## DEVELOPMENT APPLICATION ASSESSMENT REPORT

<b>Application Number:</b>	DA2023/1894
<b>Responsible Officer:</b>	Kye Miles
<b>Land to be developed (Address):</b>	Lot A DP 342493, 13 De Chair Road NARRAWEENA NSW 2099
<b>Proposed Development:</b>	Demolition works and construction of a dwelling house including swimming pool
<b>Zoning:</b>	Warringah LEP2011 - Land zoned R2 Low Density Residential
<b>Development Permissible:</b>	Yes
<b>Existing Use Rights:</b>	No
<b>Consent Authority:</b>	Northern Beaches Council
<b>Land and Environment Court Action:</b>	No
<b>Owner:</b>	Jonathan David McCall Nicky McCall
<b>Applicant:</b>	Amde Construction Pty Ltd
<b>Application Lodged:</b>	12/01/2024
<b>Integrated Development:</b>	No
<b>Designated Development:</b>	No
<b>State Reporting Category:</b>	Residential - Single new detached dwelling
<b>Notified:</b>	18/01/2024 to 01/02/2024
<b>Advertised:</b>	Not Advertised
<b>Submissions Received:</b>	1
<b>Clause 4.6 Variation:</b>	4.3 Height of buildings: 4.99%

**Figure 1.** Building height non-compliance diagram.

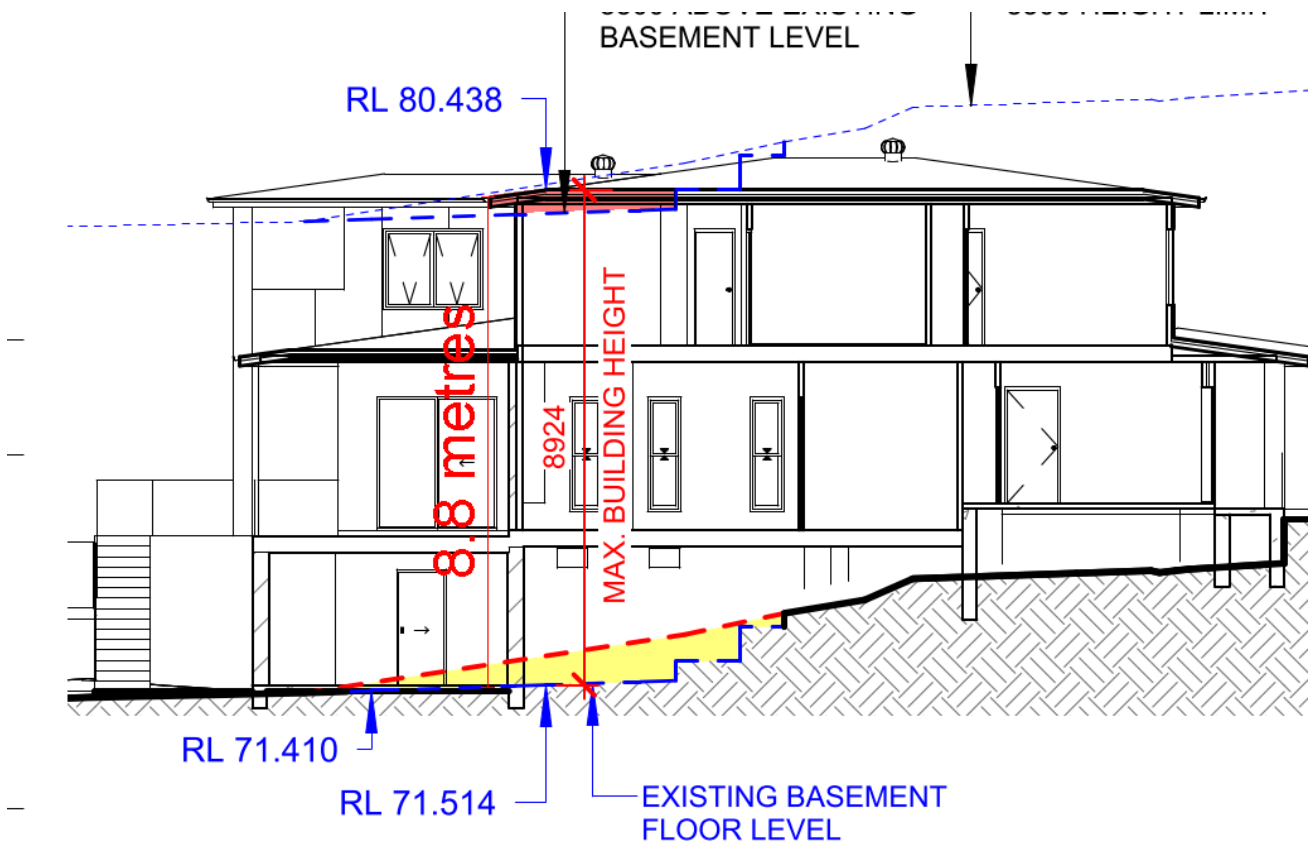
Development standard:	Height of buildings
Requirement:	8.5m
Proposed:	8.92m
Percentage variation to requirement:	4.99%

The applicant's justification is agreed with. The extent of the non-compliance is limited to the southeast corner of the roof, which largely consists of the eaves. Also, it is acknowledged that the non-compliance is largely consequence of the slope of the land that declines from north to south by

The projections above the 8.5 metre height limit are limited to the southeast corner of the building with a minor area of the 'Master' roof (demonstrated in figure 1 above). As above, this is largely consequence of existing excavation and the proposal would comply if measured from the extrapolated natural ground levels. However, these encroachments are considered to be minor and do not result in unacceptable neighbouring impacts. Overall, the proposed height is considered to be compatible and commensurate with the existing built form and therefore, remains consistent with the height and scale of surrounding and nearby development.

**Figure 2. Extent of western side boundary envelope non-compliance.**

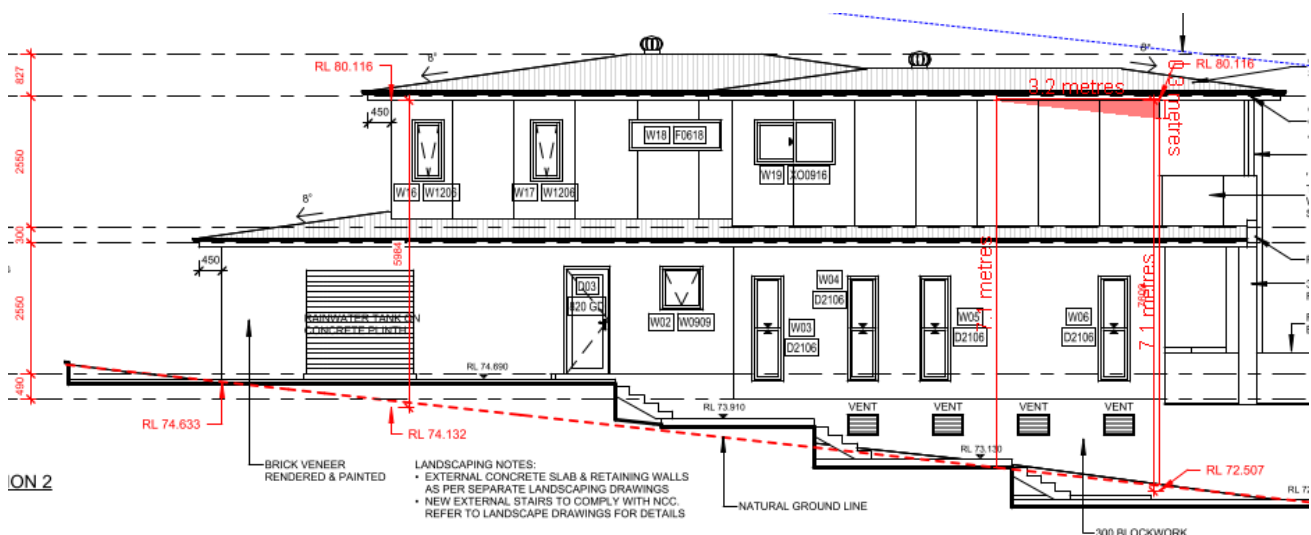
The proposal has one encroachment on the western elevation up to 0.3 metres in height for a length of 3.2 metres. This represents a maximum variation of 7.5%.
